**To:** Andrew Simpson  
**From:** Antony Williams  
**Date:** 2 November 2021  
**Subject:** Elevation at Greystanes  
Operational Noise Impact Assessment  
Loading Dock Absorption - Warehouse 2

**At:** Aliro Group  
**At:** SLR Consulting Australia Pty Ltd  
**Ref:** 610.30454-M01-v0.1-20211102.docx

This memo provides additional information regarding the proposed loading dock absorption for Warehouse 2 at Elevation at Greystanes. This acts as an addendum to SLR Report 610.30560 – *Elevation at Greystanes, Operational Noise Impact Assessment, Warehouse 2, SSD 10399*, dated October 2021 (the SSDA Report).

**Figure 1 Recommended Absorption Areas – Warehouse 2 Awnings**

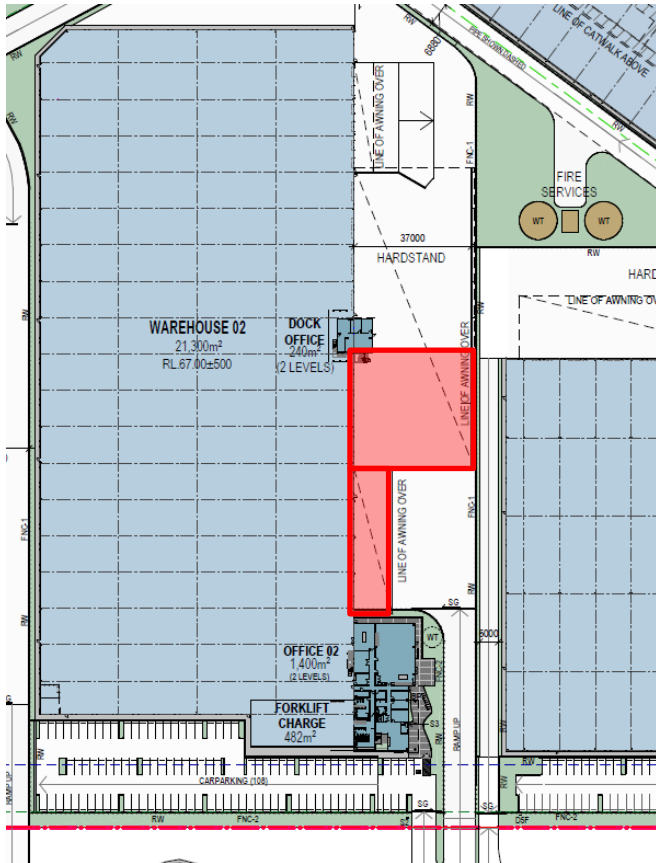
The SSDA Report recommended absorption be used in the loading dock area of Warehouse 2 to reduce noise emissions from the site. The areas where absorption is recommended to be applied are shown in red in **Figure 1** and **Figure 2**.

- Absorption applied to the eastern facade of the warehouse and underside of the canopy in the areas shown.
- The absorption should have a minimum Noise Reduction Coefficient (NRC) of 0.8. For example, this could be achieved using:
  - 75 mm thick glasswool/rockwool (hydrophobic) insulation 32 kg/m<sup>3</sup> protected by perforated steel cladding (with an open area of 11%)
  - 36 mm of Monoglass spray on insulation.
